IFB #2009-4640-2205

Public Safety Building Renovations

ADDENDUM 3

SKA-01

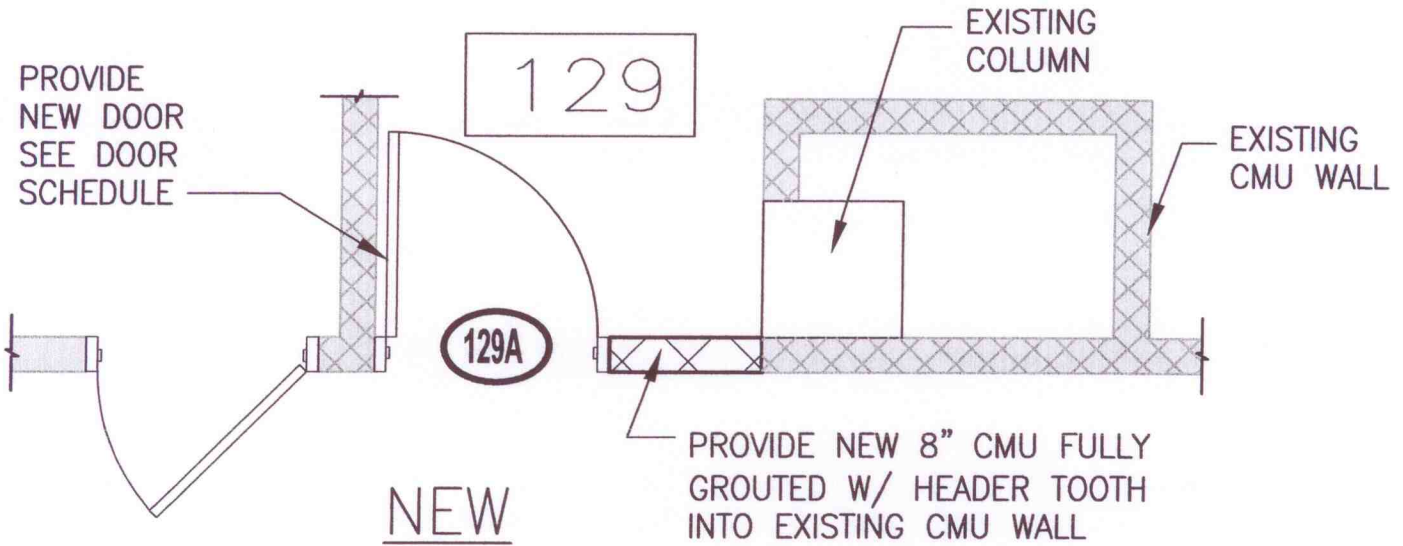
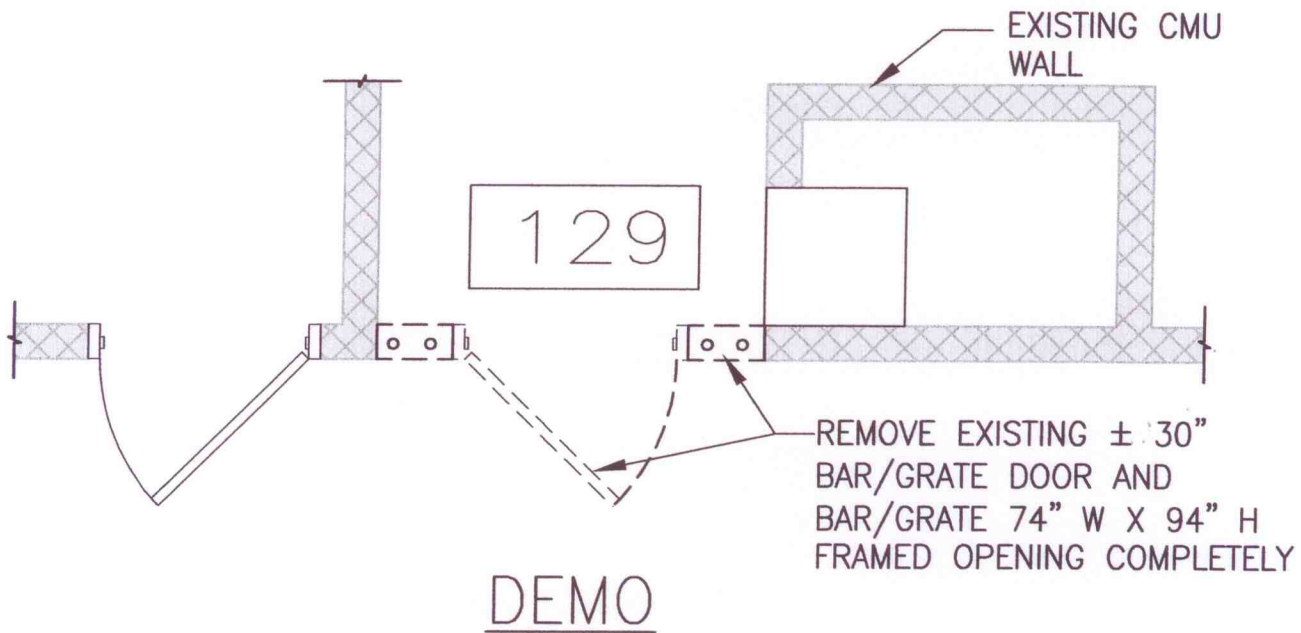
Door number 129A is an existing +/-30" bar grate door in a bar grate frame that is 72" wide by 94" high. Bar grate door and frame has additional plates attached to it on the inmate side. Contractor is to remove the whole door/frame assembly completely and disassemble to remove from project and install a new security door with hardware and DE controls in a new security hollow metal frame in a new 8" grouted solid CMU wall to match existing to fill in the opening left from the existing frame.

SKA-1 Revision to first floor plan at door number 129A to reflect as built conditions and new design conditions.
